This sheet transmits Revision 01 to Service Bulletin 500-27-A026.

FLIGHT CONTROLS - AILERON TRIM TAB, RUDDER TRIM TAB AND ELEVATOR TRIM TAB INSPECTION AND TORQUE

SERVICE BULLETIN

FIGURE 1 - AILERON TRIM TAB INSPECTION
(SHEET 01 OF 02)

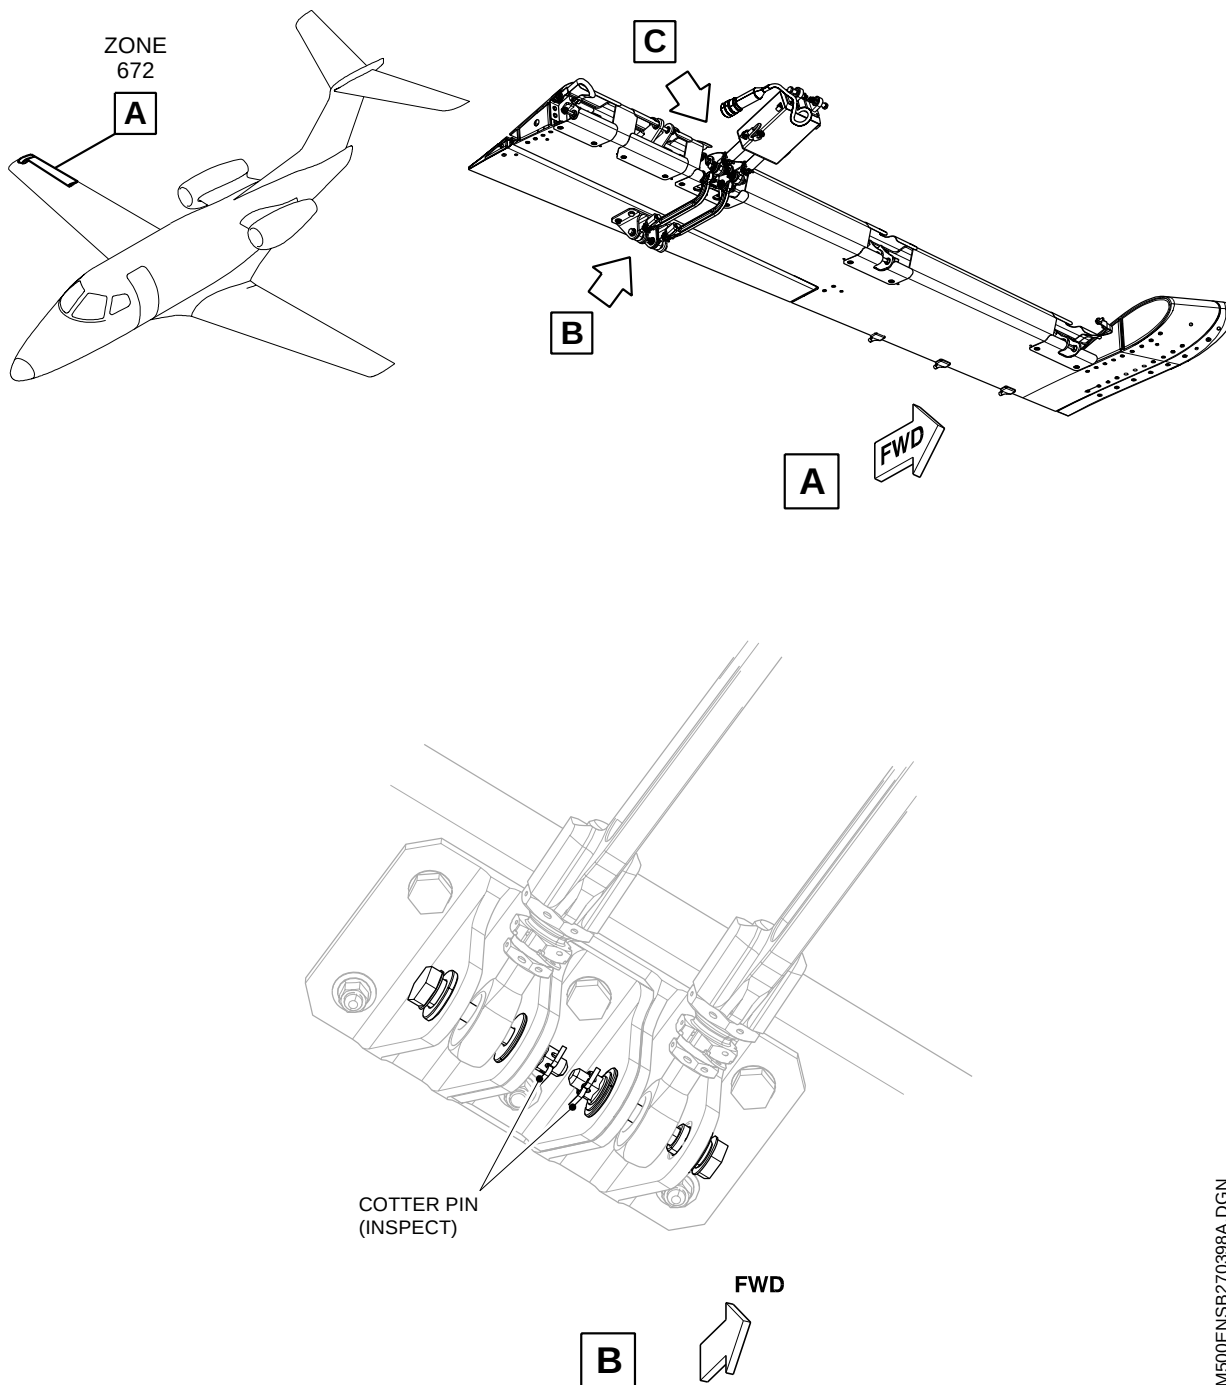
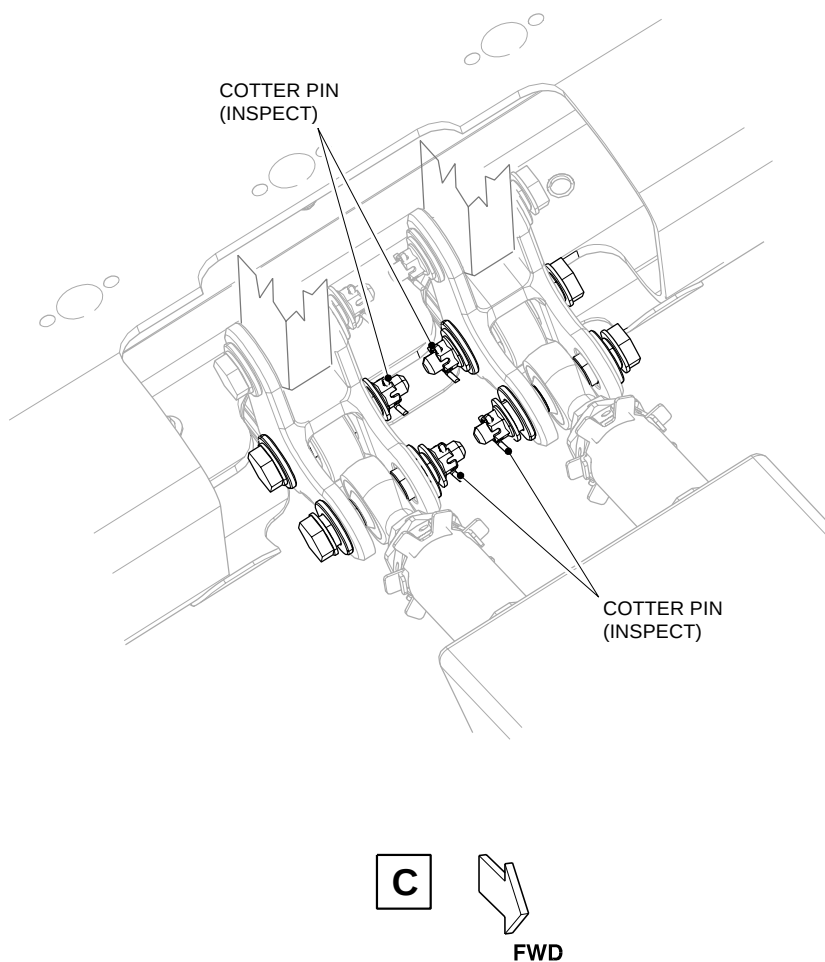
- (1) Inspect the aileron trim tab, rudder trim tab and elevator trim tab attachment points to make sure the cotter pin is installed. Refer to [Figure 1](#), [Figure 2](#) and [Figure 3](#).

- (2) If the cotter pin is installed, no action is required.

- (3) If the cotter pin is not installed, perform PART II of this service bulletin.
